PIC18F26/46/56Q83 Silicon Errata and Data Sheet

PIC18F26/46/56Q83

The PIC18F26/46/56Q83 devices that you have received conform functionally to the current device data sheet (DS40002253D), except for the anomalies described in this document.

1.6.1 UART TXDE Signal May Go Low before the STOP Bit Has Been Entirely Transmitted

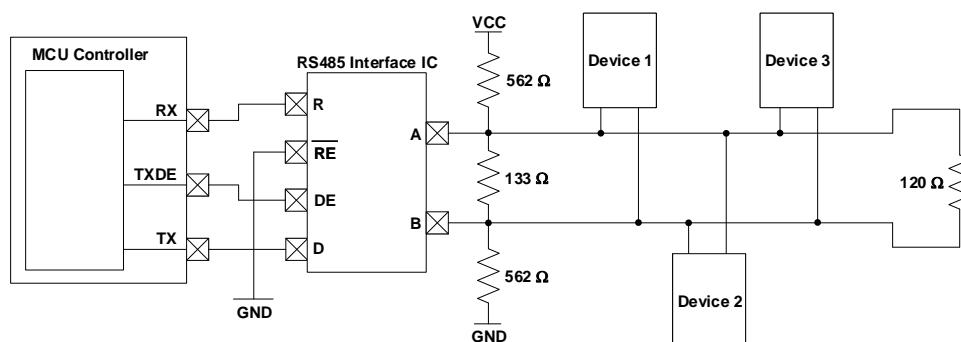
The UART Transmit Drive Enable (TXDE) signal could potentially transition into a low state before the UART STOP bit has been entirely transmitted due to the effects of parasitic capacitance on the TX line. In some applications, this could result in communication being prematurely terminated due to the TXDE bit going low before the STOP bit has had enough time to settle.

To ensure that the STOP bit settles into its final logic state before the TXDE signal transitions low, a biasing circuit can be implemented. A biasing circuit allows the TX line to either be driven high or low, rather than being left in a floating tri-state mode where prolonged rise or fall times could lead to communication being disrupted. This bias circuit should only be implemented on one end of the serial bus, and a termination resistor should be used on the other end. The figure below shows an example of a bias circuit that can be used to achieve this.

Please note that the resistor values used in this circuit are recommendations and that the actual resistor values required may vary based on the application.
